Project	IEEE 802.16 Broadband Wireless Access Working Group < http://ieee802.org/16 >	
Title	Clarification of CQICH allocation request header	
Date Submitted	2005-05-04	
Source(s)	Yongseok Jin, Bin-Chul Ihm, Jin Young Chun, and Ki-seon Ryu LG Electronics Inc. Hyoung Kyu Lim, Hyunjeong Kang, Jungje Son Samsung Electronics.	Voice: 82-31-450-7187 Fax: 82-31-450-7129 jayjay@lge.com hk03.lim@samsung.com
Re:	Response to Sponsor Ballot on IEEE802.16e/D7 document.	
Abstract	In the case that MS requests CQICH bandwidth to report the data that are much longer than 4 or 6bit, this becomes impossible because data must be transmitted over a CQI channel which is based on 4 or 6 bits. Revised text is pink	
Purpose	We suggest to add a new table which consists of the feedback contents only transmitted over CQICH for feedback type of this header	
Notice	This document has been prepared to assist IEEE 802.16. It is offered as a basis for discussion and is not binding on the contributing individual(s) or organization(s). The material in this document is subject to change in form and content after further study. The contributor(s) reserve(s) the right to add, amend or withdraw material contained herein.

Figure 20d—CQICH allocation request header

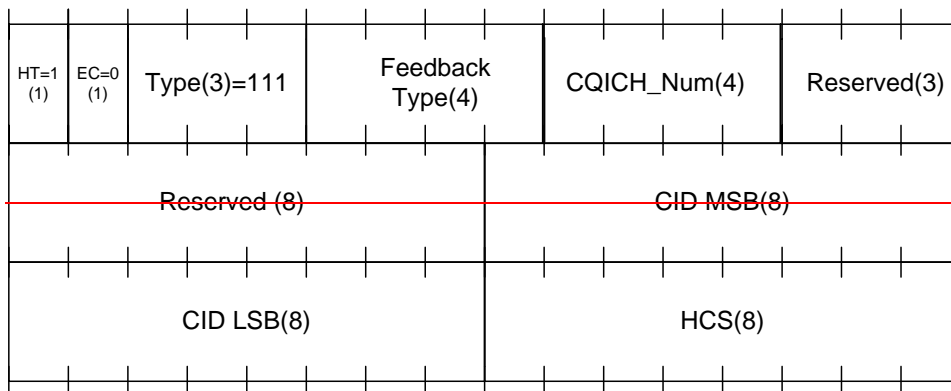
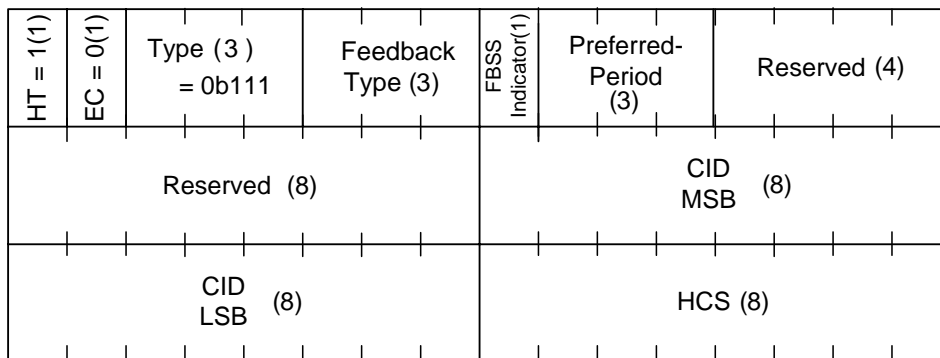
To solve the problem above, we suggest to add a new table-7x which consists of the feedback contents transmitted over CQICH. Moreover, the new table includes that 'Anchor BS report' field for Fast Anchor BS selection Feedback mechanism In addition, in order that MS requests BS to allocate Fast-feedback channel with period which MS prefer, we add 'Preferred-Period'.

[To clarity, add new table and new field in the section 6.3.2.1.2.3]

The CQICH Allocation request PDU shall consist of CQICH allocation request header alone and shall not contain a payload. [This header shall be sent by MS to request the allocation of CQICH](#) .The CQICH allocation request header is illustrated in Figure 20d

- a) [The length of the header shall always be 6 bytes.](#)
- b) [The EC field shall be set to 0, indicating no encryption.](#)
- c) [The CID shall indicate the MS basic CID.](#)
- d) [The Type field shall be 0b111.](#)

[The fields of the CQICH allocation request header are defined in Table 7c](#)

Name	Length(bits)	Description
HT	1	Header Type =1
EC	1	Always set to zero
Type	3	Set according to Table 7i Type = 0b111
Feedback type	3	Set according to 'Feedback type' of Table 302a When FBSSI is set to 1, this field is neglected
CQICH_Num	-4	The number of CQICH requested by MS
FBSS Indicator	1	Set when MS request CQICH during FBSS handover.
Preferred-Period(=p)	3	CQICH allocation period MS prefer. The value is defined by 2^p frame. When FBSSI is set to 1, the value contained in this field shall be neglected
RSVD	12	Set to zero
CID	16	MS basic CID
HCS	8	Header Check Sequence (same usage as HCS entry in Table 5)
